Memorandum

To: Louisa Armstrong - Christchurch City Council

Re: Further Information Response –78 Park Terrace and 100 Park Terrace, Christchurch

Figure 1: Bishops Park Typical Cross-Section of Stormwater Overland Flow Philosophy

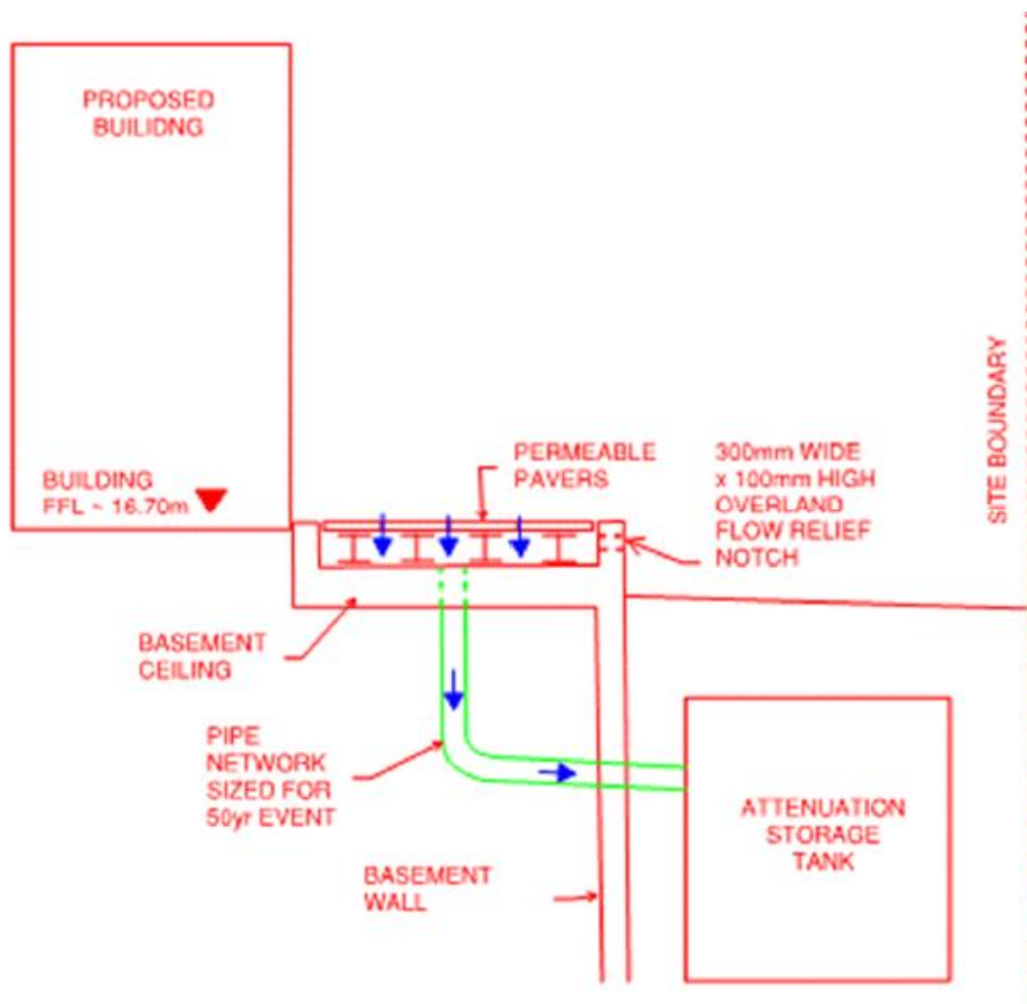
The application states the Bishopspark site will achieve the FFL of 16.7m and that conventional overland flow paths are provided within the site margins, discharging to the legal road frontages. The west end of the overland flowpath into Westwood Tce appears to be higher than the FFL in the site, so discharging to the road frontage would be difficult.

The drainage philosophy, as detailed in the Civil Design Report by Beca, is to store stormwater up to the 50-year event in attenuation storage tanks – as shown in Figure 1 below (being a replicate of Figure 15 in Civil Design Report). Therefore, the primary pipe network has been sized to convey the 50-year peak flow to the attenuation storage tanks. Some additional measures have been provided in the design to provide overland flow relief to the proposed buildings for events greater than the 50-year event.

As per the drawings attached as **Appendix E**, the vertical tie in point along the boundary with Westwood Terrace varies - but is approximately RL 16.80 to 16.85 m. This is a little higher than the floor level of the proposed buildings at the Bishops Park site. On the western side of Westwood Terrace the grading takes this height out and contains the 50-year event flow within the site and discharges through the permeable pavers in the pipe network (as per Figure 1 below). A modular trench drain adjacent to Westwood Terrace, sized for the 50-year peak flow, is proposed in front of Building B01. Another drain is proposed along the eastern boundary to discharge the 50-year peak flow to the attenuation storage tank.

Consequently, the 50-year peak flow does not discharge as overland flow to Westwood Terrace.

For events greater than the 50-year event, a sump is provided at the eastern boundary of the site with Westwood Terrace. This sump provides overland flow relief for events greater than the 50-year event should the stormwater tank fill up and overflow through connection to the boundary ACO Drain. These flows will subsequently discharge to Westwood Terrace and Salisbury Street by overland flow.
